SOUTH ACADEMY BUSINESS CENTER

4425 HWY 85-87
EL PASO COUNTY, COLORADO
SITE DEVELOPEMENT PLAN

FILE NO.
PCD 17-004

Markup Summary

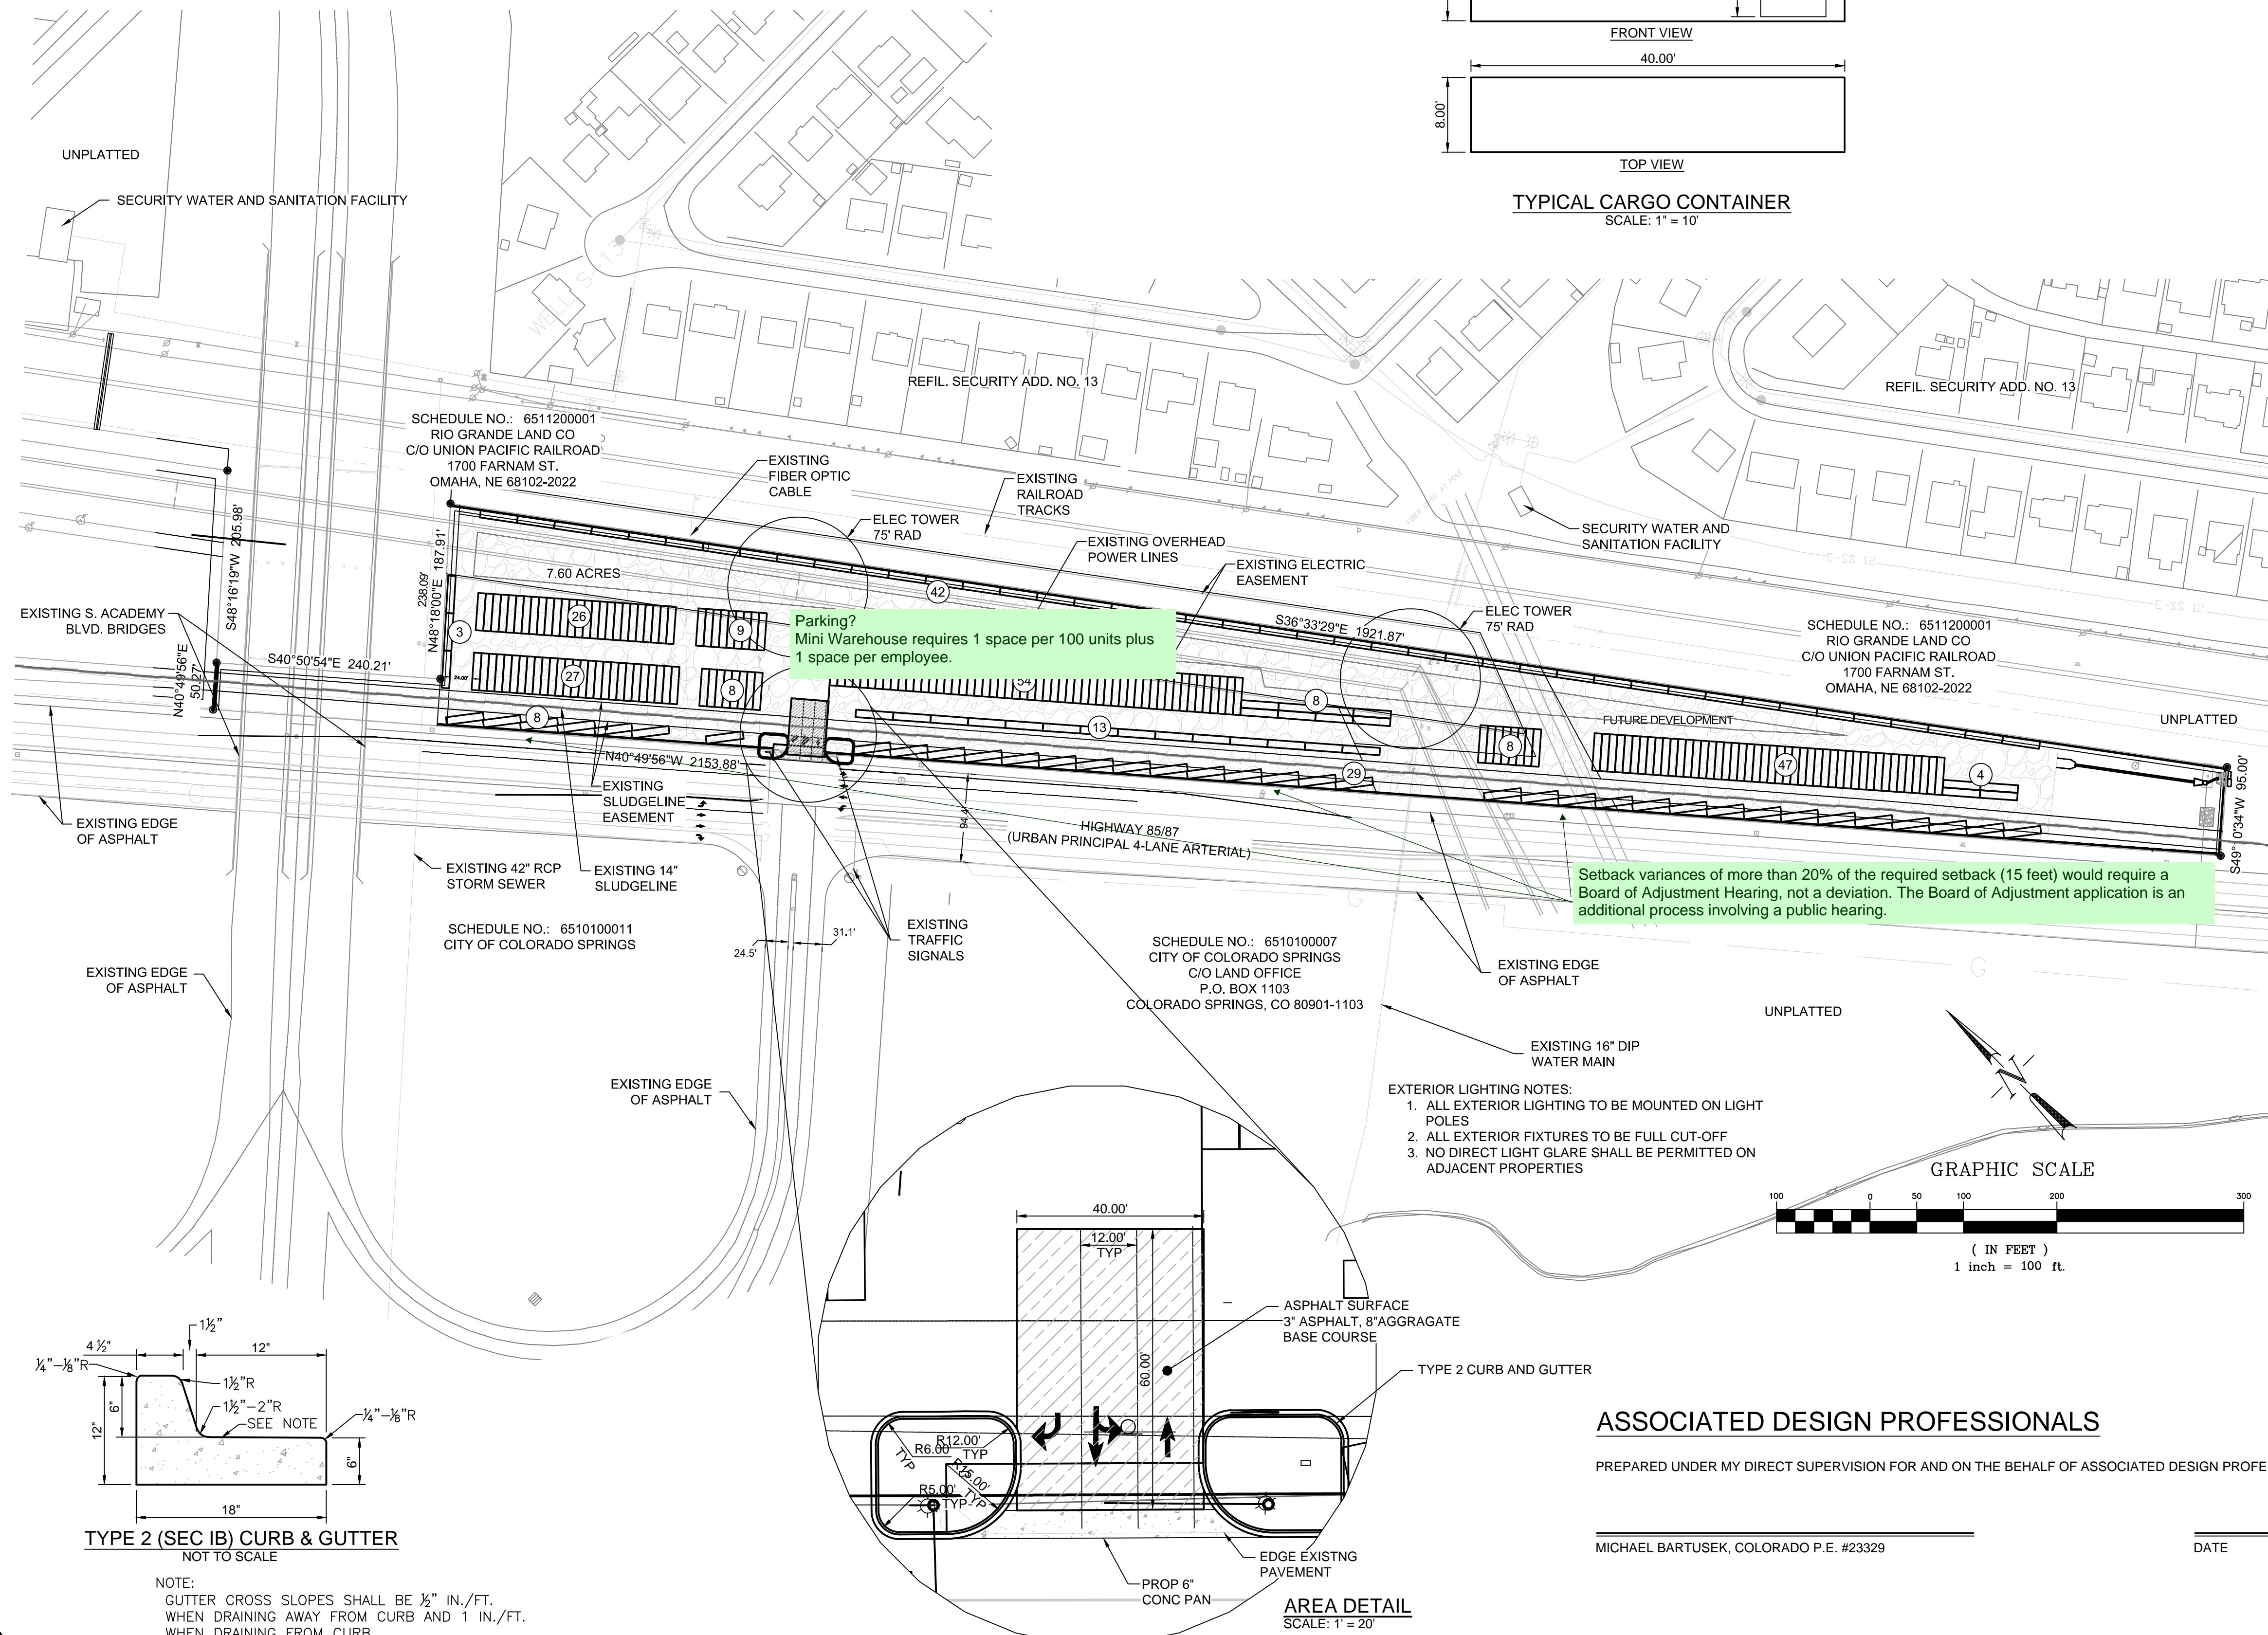
Parking? Mini Warehouse requires 1 space per 100 units plus 1 space per employee. (1)

Setback variances of more than 20% of the required setback (15 feet) would require a Board of Adjustment Hearing, not a deviation

These measurements should be the same. It looks like the 8' measurement is below the top of the structure, it should be corrected.
